UNITED STATES PATENT AND TRADEMARK OFFICE

Office Action Summary

10/572,378

KOIZUMI ET AL.

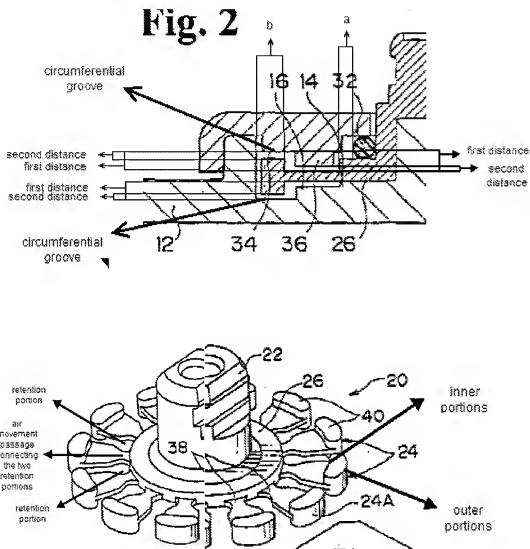
Regarding **claims 1 and 3-14**, Hayashi discloses all claimed elements set forth in the figures above and the last office action mailed on 01/15/2008, but Hayashi does not disclose a smooth outer periphery of the rotor extending continuously without interruption, but Sugawara discloses a damper device (figs. 5a-5d) with a rotor (6) having a smooth outer periphery extending continuously without interruption. It would have been obvious to one of ordinary skill in the art at the time the invention was made to make the rotor of Hayashi having a smooth outer periphery extending continuously

without interruption as taught by Sugasawara, because a smooth outer periphery of the rotor extending continuously without interruption will provide an improved high torque damper device for producing variable amount of torque which is relatively simple and economical to manufacture and assemble.

Hayashi does not disclose the arc shaped air retention portions being formed by elongated through-bore as claimed, but Sugasawara discloses a damper device (figs. 5a-5d) with a rotor (6) having an arc shaped air retention portions (see figure below) being formed by elongated through-bore (6c). It would have been obvious to one of ordinary skill in the art at the time the invention was made to make the disc of Hayashi with the arc shaped air retention portions being formed by elongated through-bore as taught by Sugasawara, because the arc shaped air retention portions being formed by elongated through-bore will accelerate the flow of viscous liquid to ensure a smooth movement of viscous liquid.
